Town of Surfside
Special Town Commission - Quasi-Judicial Hearing
AGENDA
Tuesday, April 12, 2022
6:00 PM
Commission Chambers - 9293 Harding Avenue
Surfside, FL 33154

2.A 9165 Collins Avenue – Hillcrest by the Sea – 9165 Surfside LLC Site Plan Approval - Andrew Hyatt, Town Manager

Subject: **9165 Collins Avenue – Hillcrest by the Sea – 9165 Surfside LLC Site Plan Approval**

SITE PLAN REPORT

ZONING INFORMATION & BUILDING DATA SHEET NO. **A2.00**

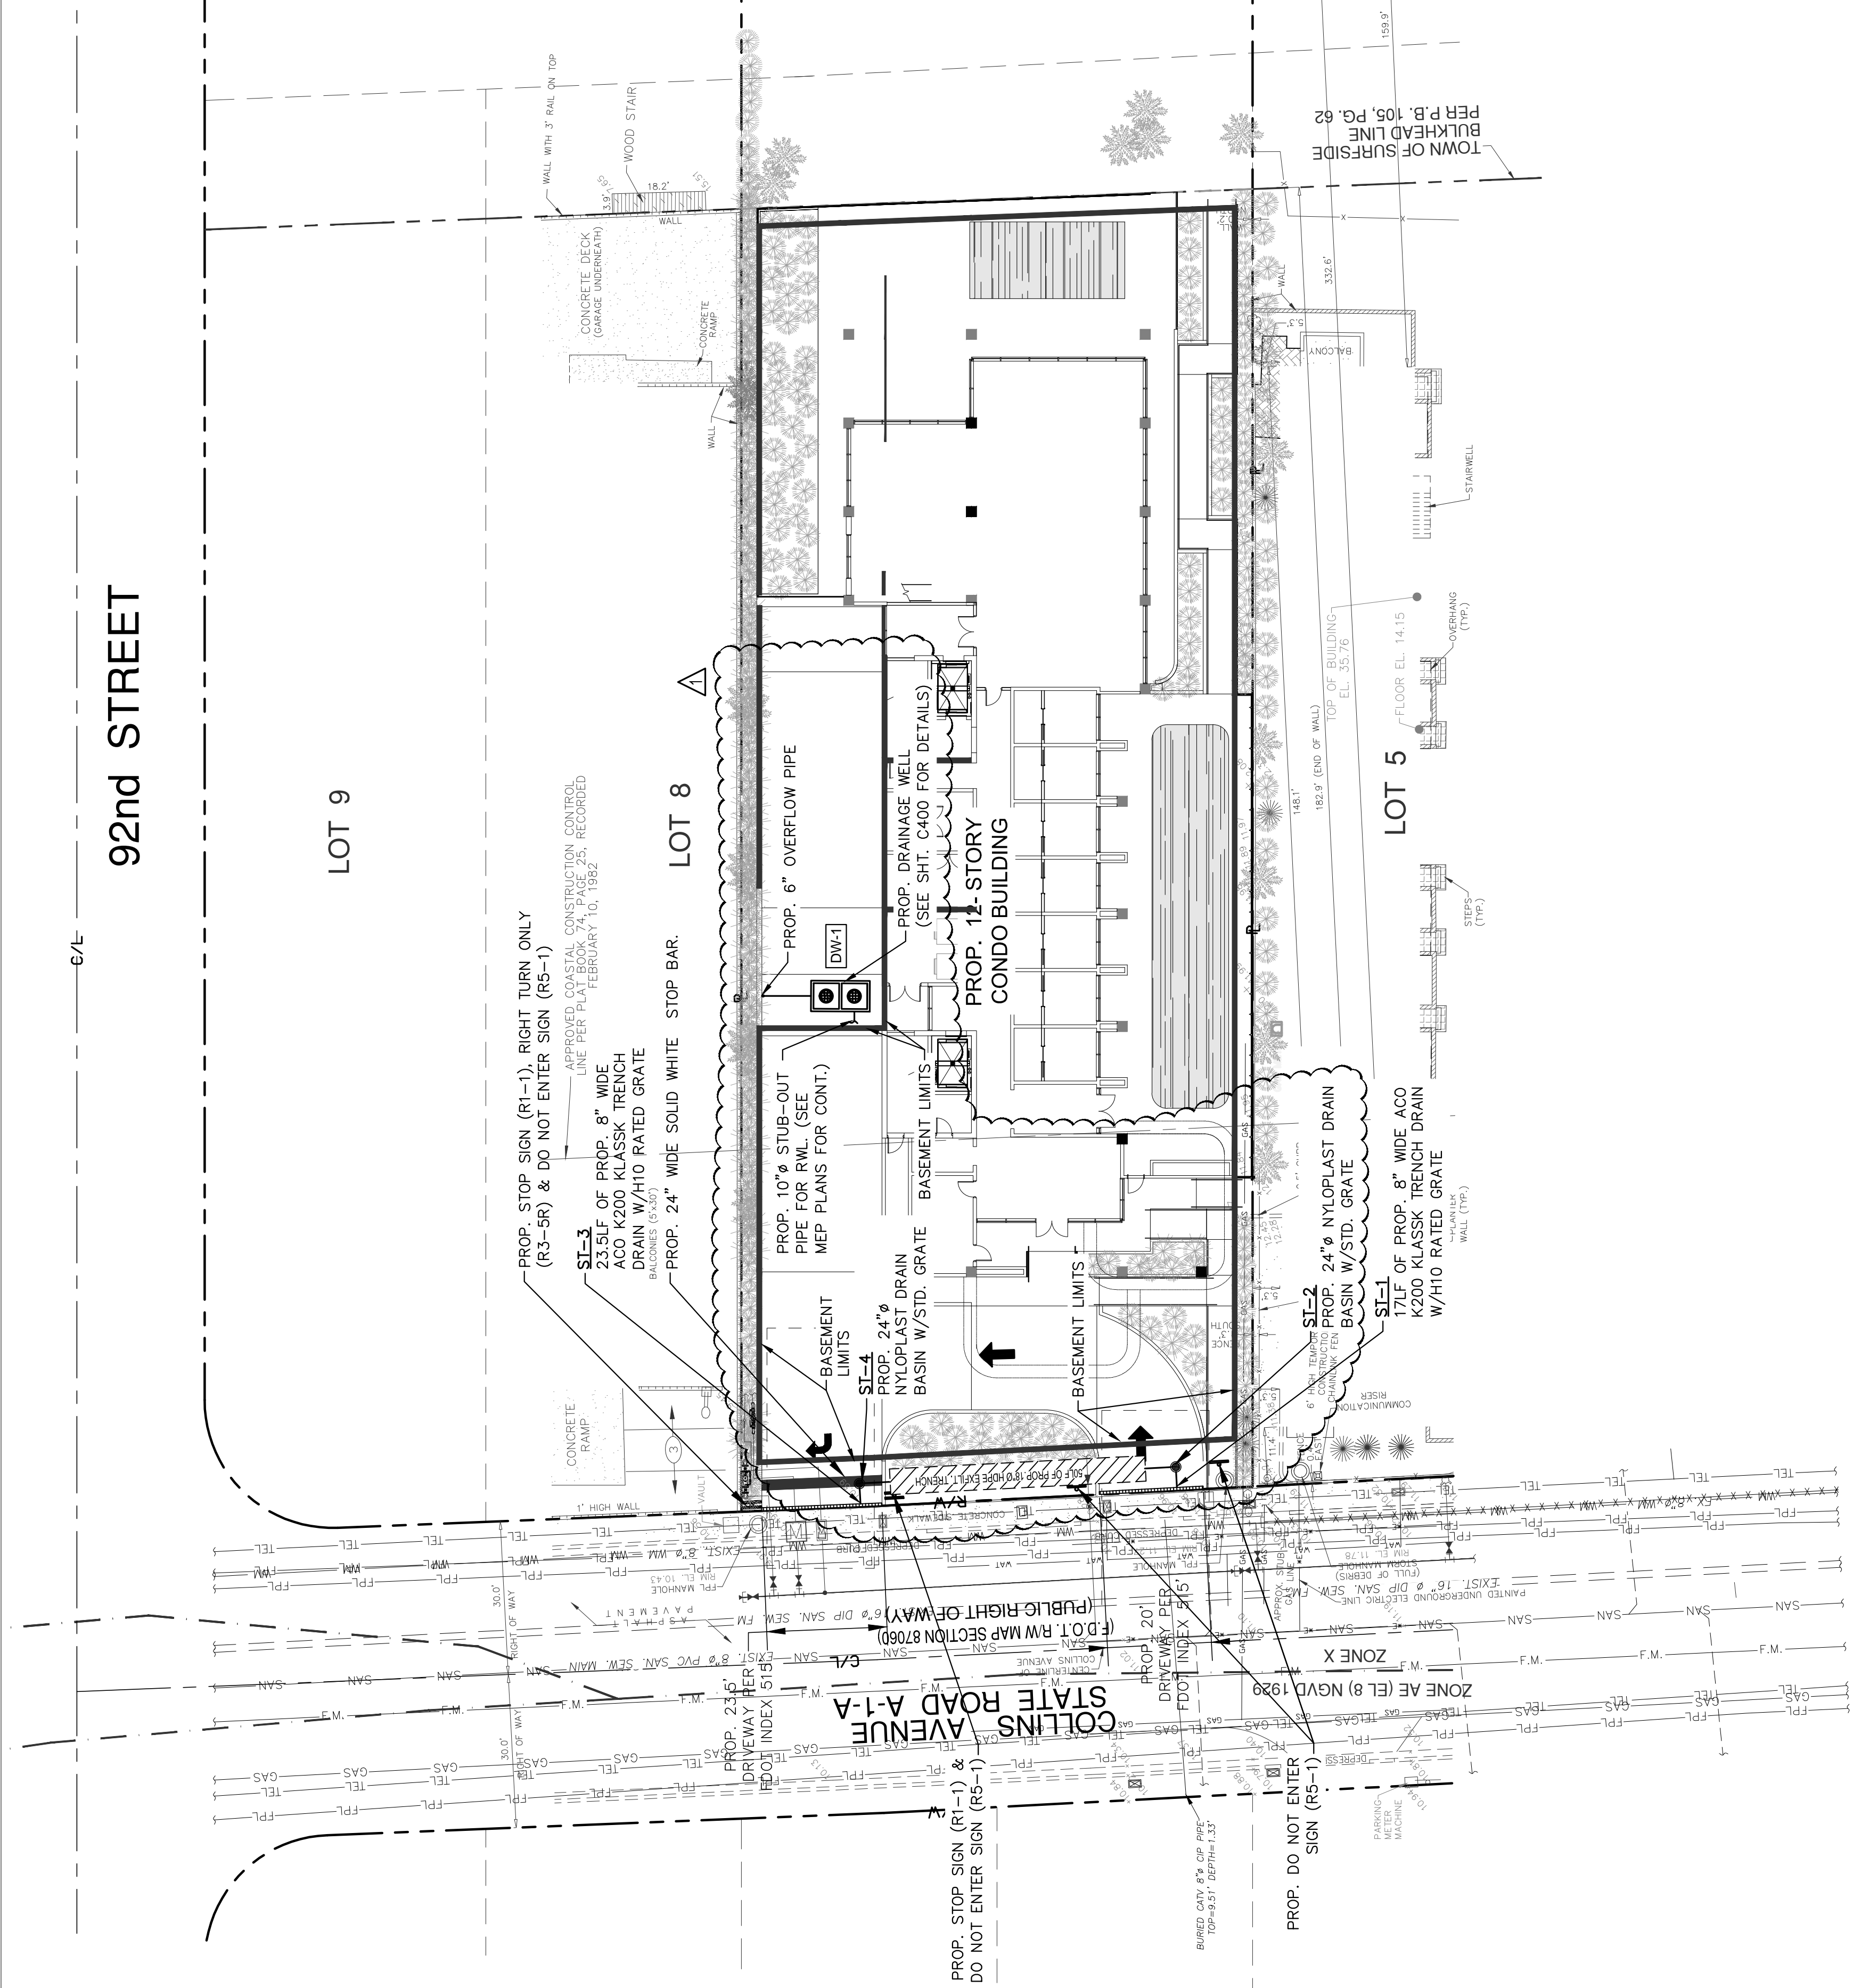
DEFINITION		
SETBACKS		
PRIMARY FRONTAGE		
SIDE	10% OF THE LOT FRONTAGE, NO LESS THAN 10 FEET OR 20% OF LOT FRONTAGE + ADDITIONAL 5% AVERAGE (25% TOTAL) WHEN A BUILDING EXCEEDS HEIGHT OF 30', THE WIDTH OF EACH SIDE YARD SHALL BE INCREASED BY 1' FOR EVERY 2' OF BUILDING HEIGHT ABOVE 30'	40'-0" MIN
SIDE (MODIFICATION)		
REAR	SILLS, CORNICES, ROOF EAVES AND ORNAMENTAL FEATURES	30'-0" MIN
PROJECTIONS INTO REQUIRED SETBACKS	OPEN, UNENCLOSED BALCONIES INTO A REQUIRED PRIMARY (FRONT), SECONDARY (CORNER), OR REAR SETBACK	2'-0" MAX
MINIMUM UNIT SIZES	OPEN, UNENCLOSED BALCONIES INTO AN INTERIOR SIDE SETBACK	8'-0" MAX
2-BEDROOM APARTMENTS	NO MORE THAN 80% OF A BALCONY'S FOOTPRINT SHALL OVERHANG THE BALCONY ON A LOWER LEVEL.	25% MAX @ 10'-0", 75% MAX @ 5'-0"
3-BEDROOM APARTMENTS		90% MAX
BUILDING HEIGHT		
DEFINITION	Fat Roofs: The vertical distance from the average datum or elevation of the crown of the roof fronting the lot or building site, to the highest point of the roof. In the H120 district no lots or parcels where construction is regulated by the Florida Coastal Construction Code, maximum height shall be measured from the established elevation determined by the FDEP for the first floor.	120'-0"
